Project
1A RAVENSWOOD PARK
NORTHWOOD
MIDDLESEX

Drawing
EXISTING & PROPOSED SITE PLANS

5829/PL004

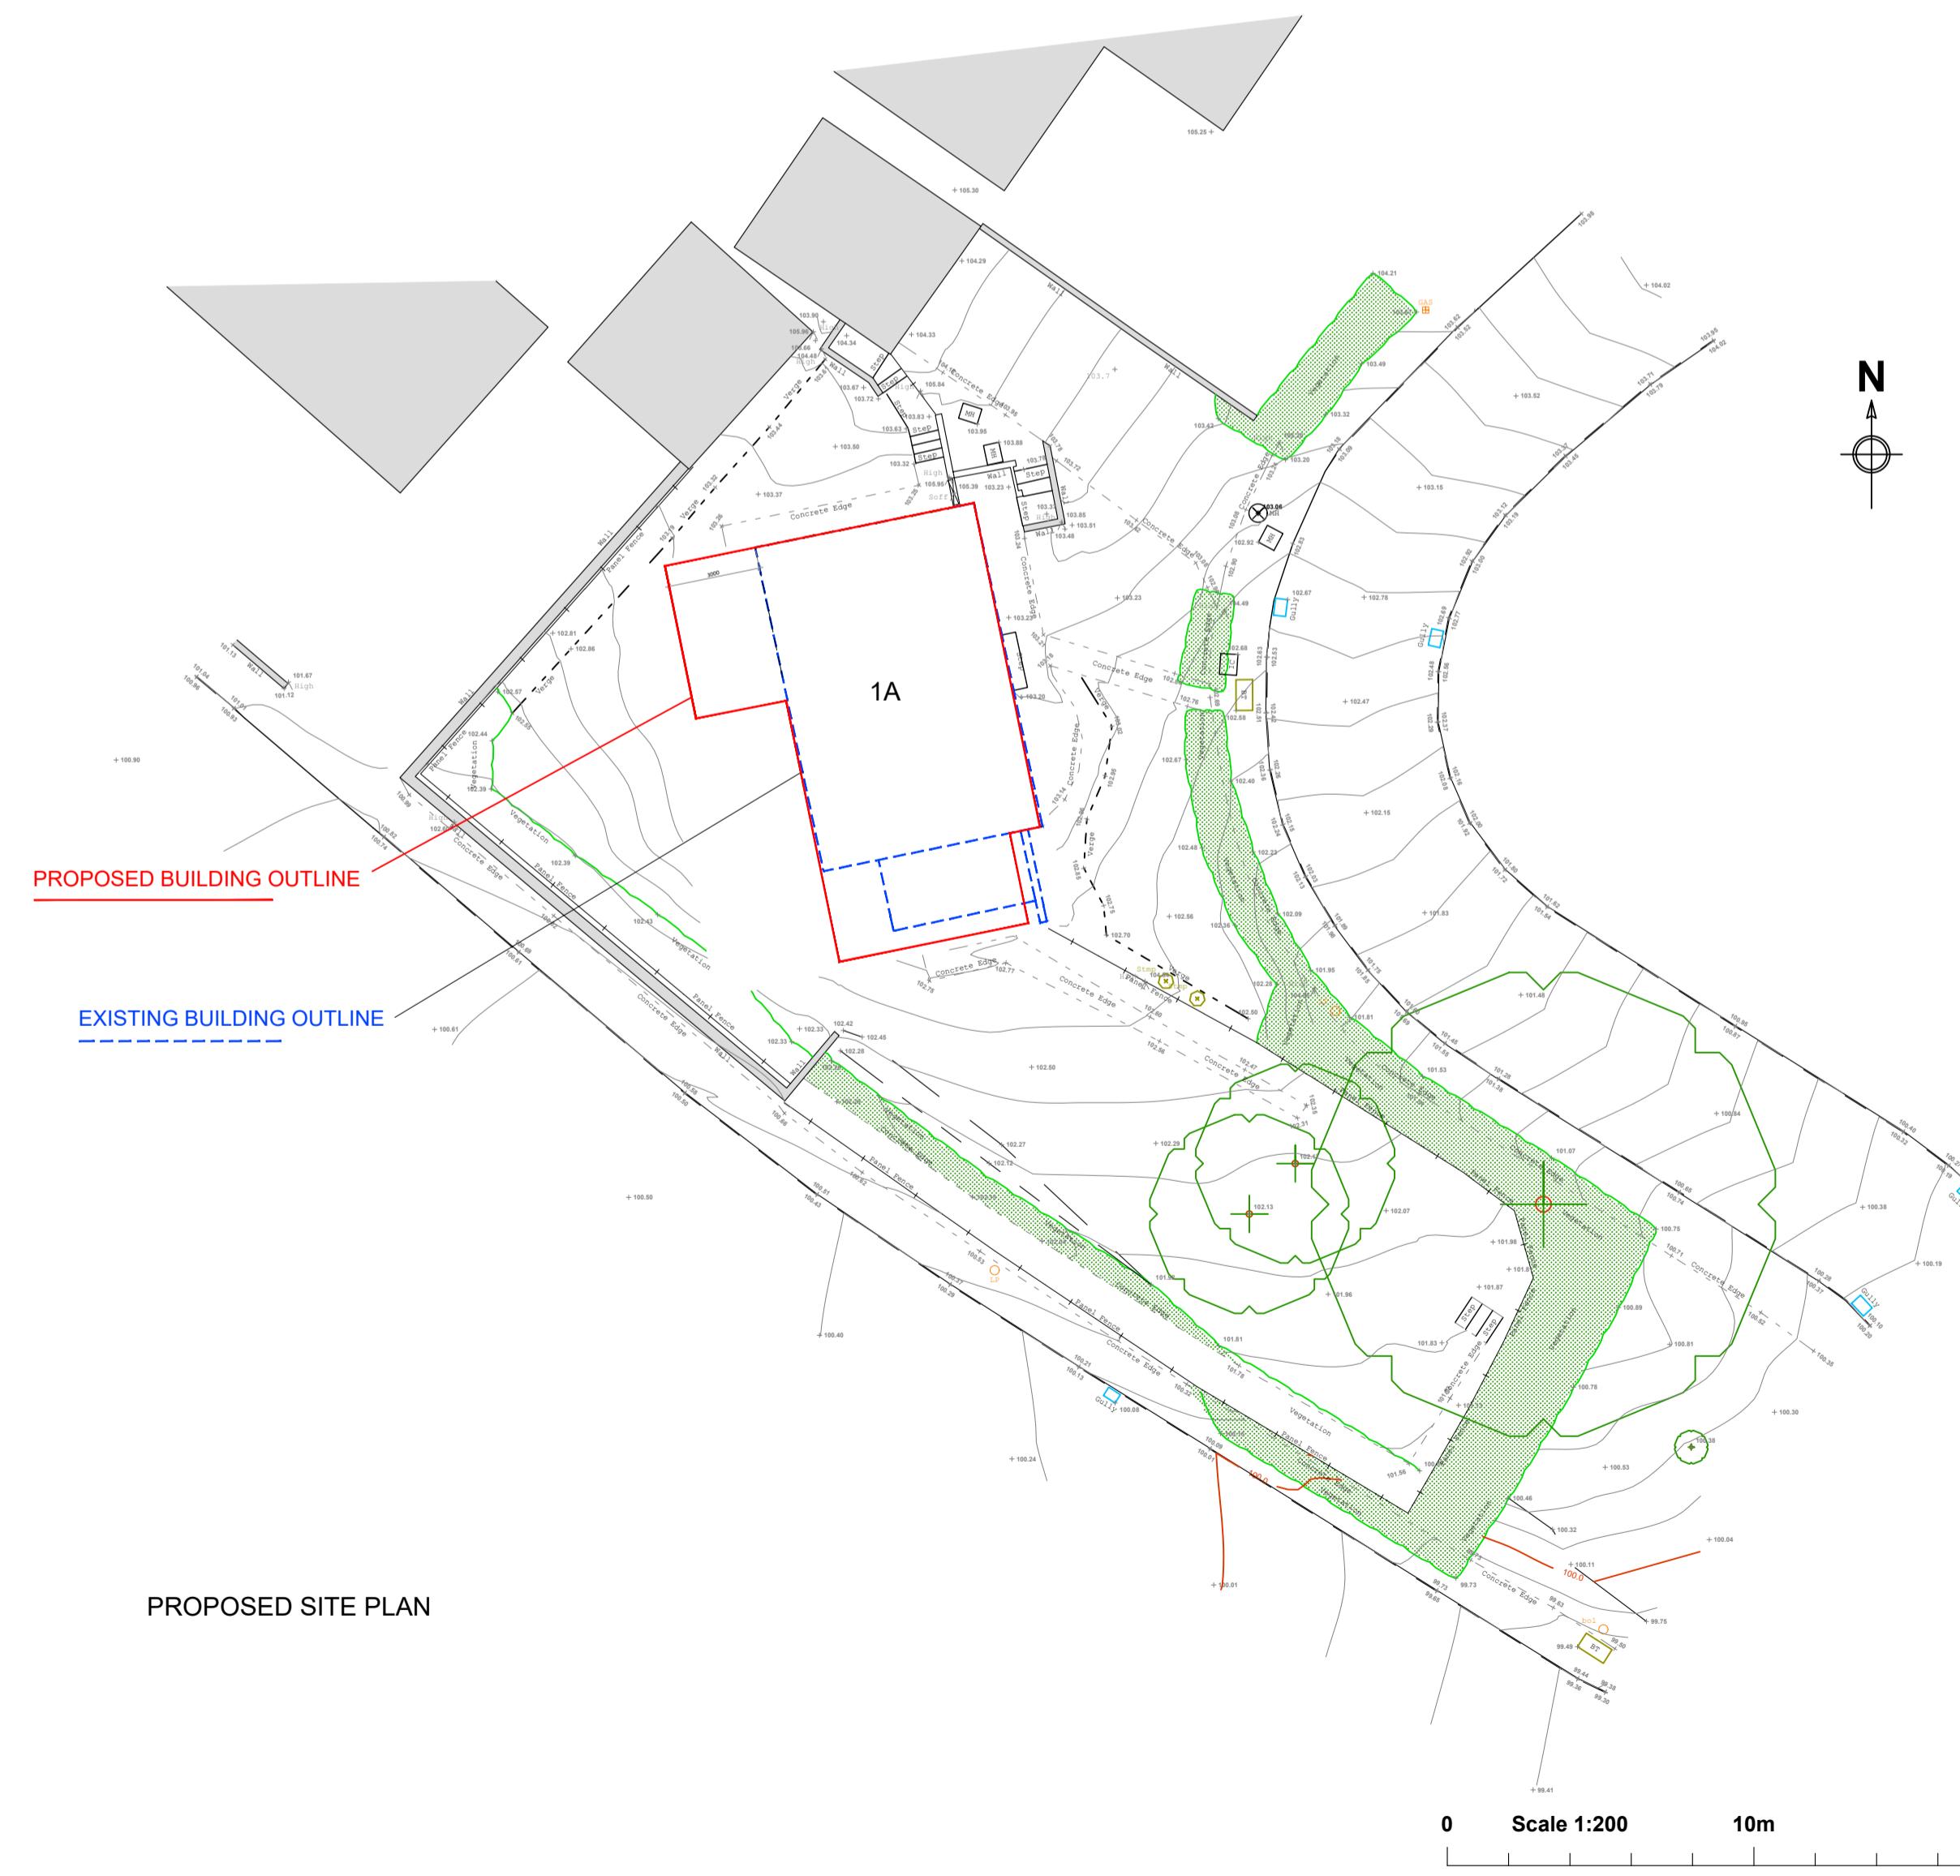
| Amendments/Notes | | | |
|------------------|--|----|----------|
| A | Proposed Site Plan updated | SL | 08.06.22 |
| B | Set back the front 1m at both levels | SL | 26.07.22 |
| C | 3m depth GFL, 2m reduced FFL extens. | SL | 27.07.22 |
| D | GFL reduced near left corner | SL | 17.08.22 |
| E | Reduced to half width the rear extension | SL | 06.09.22 |
